URBAN DESIGN CONSULTATION RESPONSE

Design Officer	Azhar Kapadi
Date	19.05.26
Application Reference	PL/2026/0316
Address	Cardinal Langley RC High School, Rochdale Road, Middleton, Manchester, M24 2GL
Proposal	Erection of a single storey building to provide a new SEND unit facility including relocation of visitor car park, alteration to north facing fenestration of existing building, installation of security fencing/gate and landscaping works

Scheme Image(s)

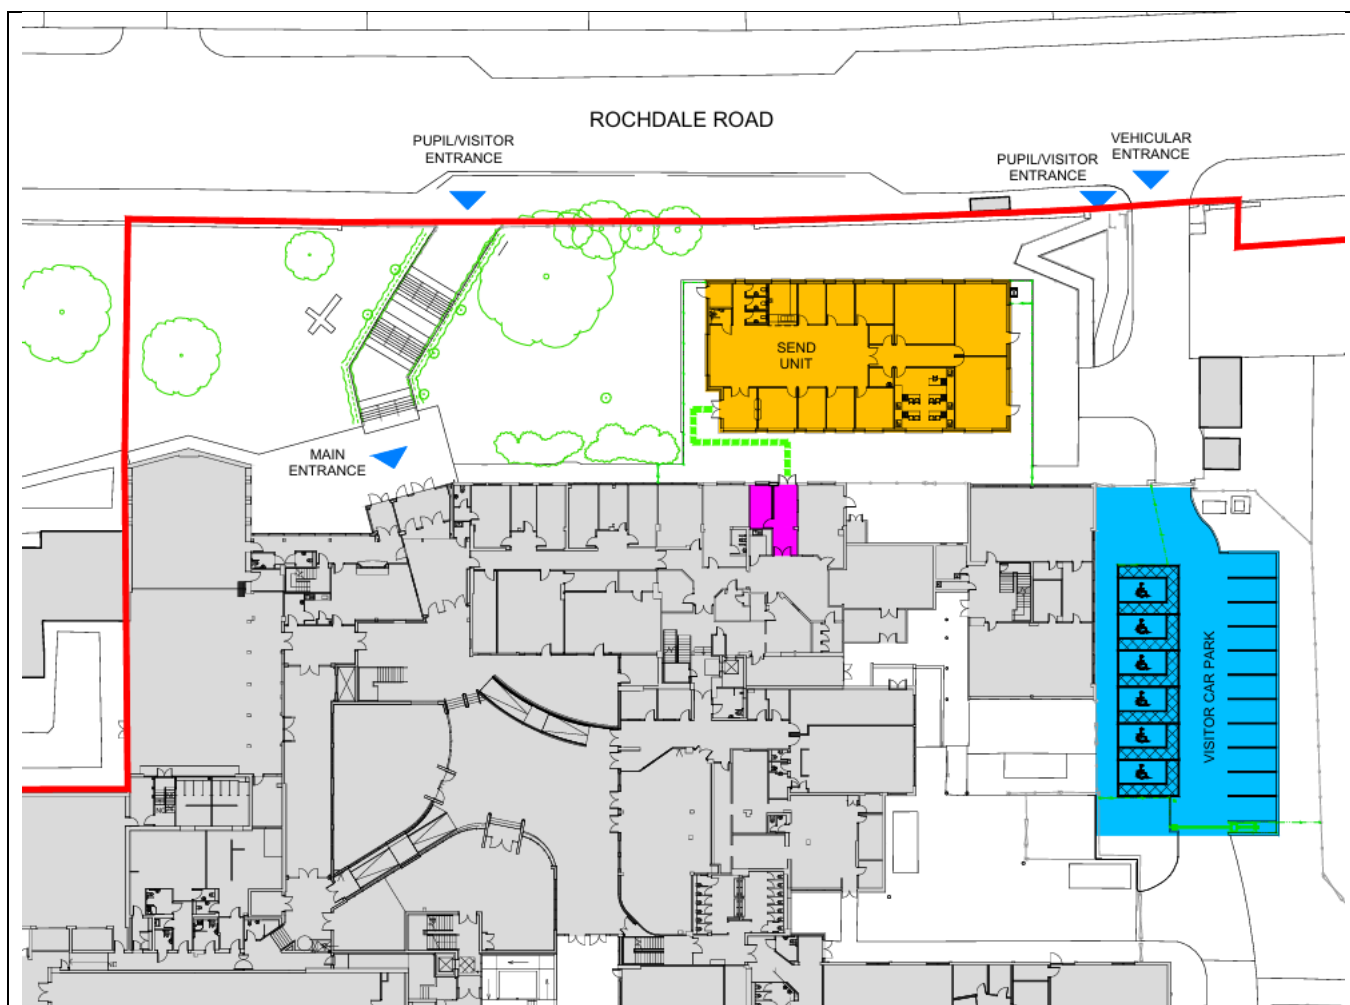
Overall, the proposal is considered to fall significantly short of expected design quality. It fails to respond to the established street character, particularly through the loss of the strong landscaped frontage and lack of a coherent replacement strategy. The building's siting and architectural approach are not adequately justified, and the absence of a clear design narrative further weakens the scheme.

The proposal does not demonstrate how landscape is incorporated around the unit, nor how the existing positive frontage buffer—formed by grass verge, planting, and boundary treatment—is retained or reinterpreted. It remains unclear how this important transitional space is maintained within the scheme.

Materials proposed are basic and uninteresting. The use of render has enough precedent in the borough to demonstrate how this has aged poorly and weakened the character of areas. The use of render does not constitute high quality design and will not be supported.

There is no real reference to architectural detail in the design. Elements such as the ‘clunky’ roof further add to poor quality design and are not supported.

The proposal does not adequately justify the loss of the strong green buffer that is characteristic of this stretch of the street. It remains unclear whether meaningful replacement landscaping is proposed, and as a result the overall approach risks creating a significantly poorer visual outlook than the existing situation. In particular, the removal of established trees and frontage planting is not convincingly addressed or mitigated.

- Street elevations / Elevations with further context
- Street views

Information regarding window reveal depths etc. Generally, an acknowledgement to design importance
